PLANNING DIVISION STAFF REPORT

April 13, 2026

Project Address: 1111-1135 Regent Street and 2 South Mills Street (District 13, Alder Evers)
Application Type: Conditional Use and Certified Survey Map
Legistar File ID #: [92236](#) and [92238](#)
Prepared By: Lisa Ernest, AICP, Planning Division
Report Includes Comments from other City Agencies, as noted
Reviewed By: Kevin Firchow, AICP, Principal Planner
Meagan Tuttle, AICP, Planning Division Director

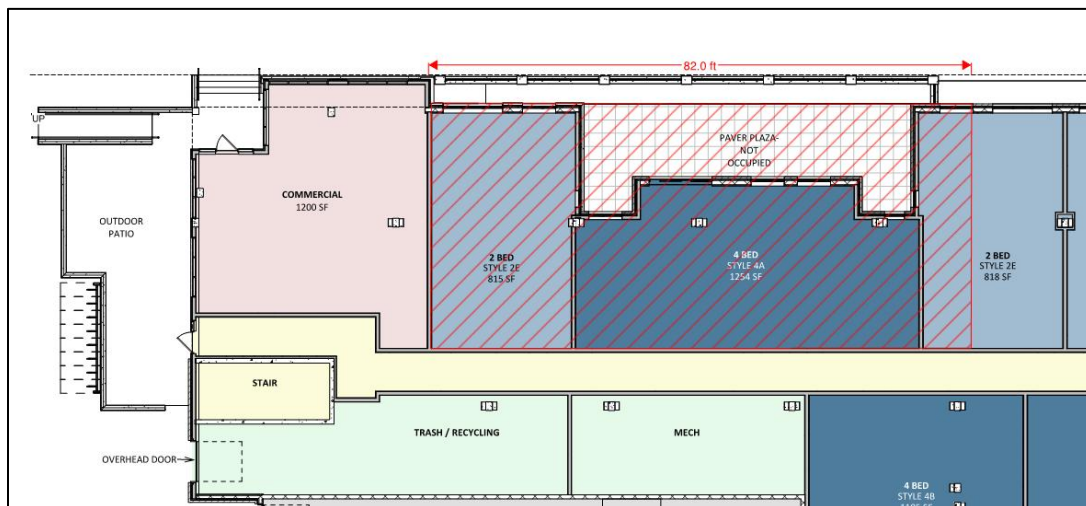
The Zoning Code requires that a minimum of 50% of the frontage along Regent Street has non-residential uses, and that there should be non-residential uses at the street corners. As proposed, approximately 10.6% of the building along Regent Street has commercial frontage. The project includes 1,200 square feet of commercial space at one street corner of the 168,373 square-foot building. There is approximately 339.5 feet of frontage, with 36 feet of commercial frontage along Regent Street. There are 245 feet between the end of the commercial

While the Zoning Code allows the Plan Commission to consider a reduction to the required commercial frontage, staff recommends a condition that the project provide more commercial frontage than is currently proposed. Specifically, staff recommend that this project provide a minimum of 35% commercial frontage along Regent Street on at least one street corner. This would require approximately 82 feet of additional commercial frontage for a total of 118 feet.

1. The building shall have approximately 35% of commercial frontage along Regent Street. The commercial frontage shall be provided on at least one street corner. Final details, including resulting façade and site plan changes shall be approved by Planning Division and Zoning Administrator. Significant changes to the building design may require a major or minor alteration as specified in MGO Section 28.183(8).

Scenario 1 shows additional commercial frontage next to the existing commercial space. This would remove approximately 2,346 square feet of residential space.

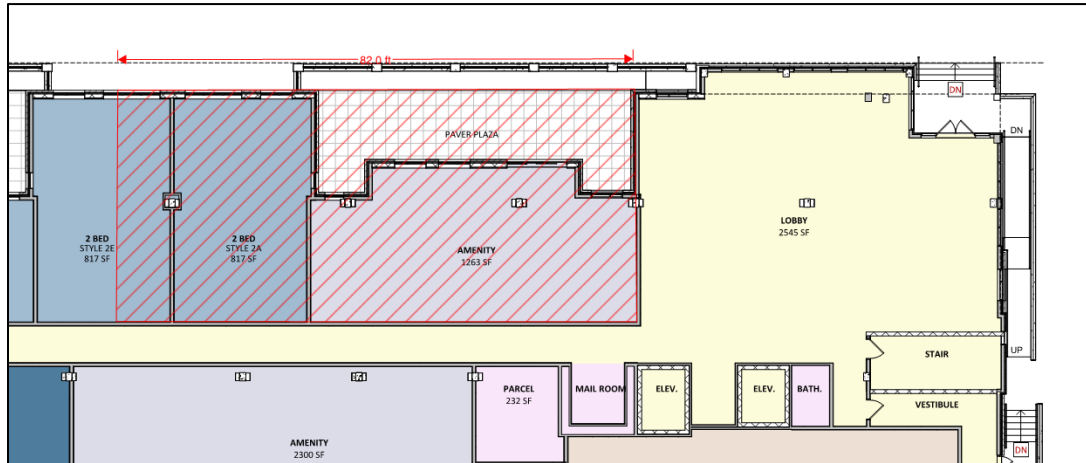
The two figures show two scenarios with 35% of commercial frontage. The additional frontage could be located next to the existing commercial space or at the corner of South Mills Street. There may be impacts to the building footprint or design to ensure it meets the commercial Building Code and accessibility requirements. Staff acknowledge that additional square footage may be needed to ensure the commercial space is located near the street.
